# UNITED STATES PATENT AND TRADEMARK OFFICE

APPLICATION NO.	FILING DATE	FIRST NAMED INVENTOR	ATTORNEY DOCKET NO.	CONFIRMATION NO.
10/696,152	10/29/2003	Hans-Peter Broghammer	696.022	9623

**Office Action Summary**

## **DETAILED ACTION**

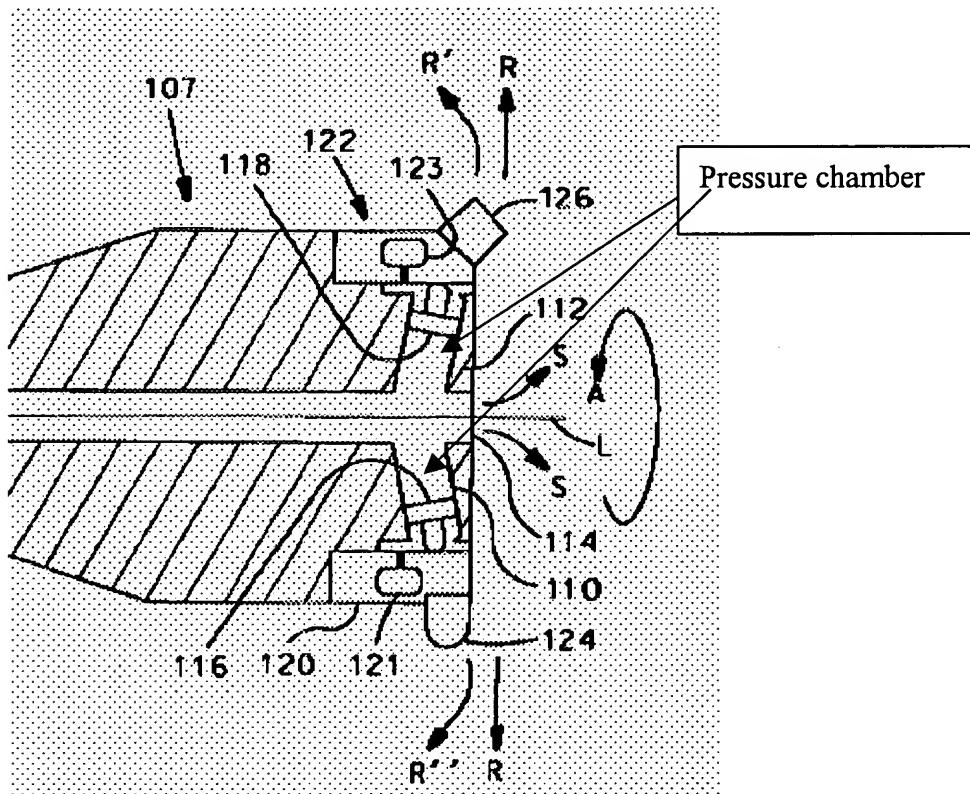
Re claim 3, note that the other embodiments taught by Hyatt function similarly to the embodiment described above, and especially see Figure 1A (for example), noting that the axial length of the pressure chamber that is labeled in the partial reproduction of Figure 1A below appears to “correspond essentially” to the length of the cutter 126.

Additionally, re claim 4, it appears that in the embodiment of Figure 1A, the axial length of the aforescribed “pressure chamber” is “limited to the region of the tool corner”, as best understood.

Re claim 12, it is noted that via the exit conduit 114 shown in Figure 1A, the pressure chamber shown above can be considered to be “ring” shaped.
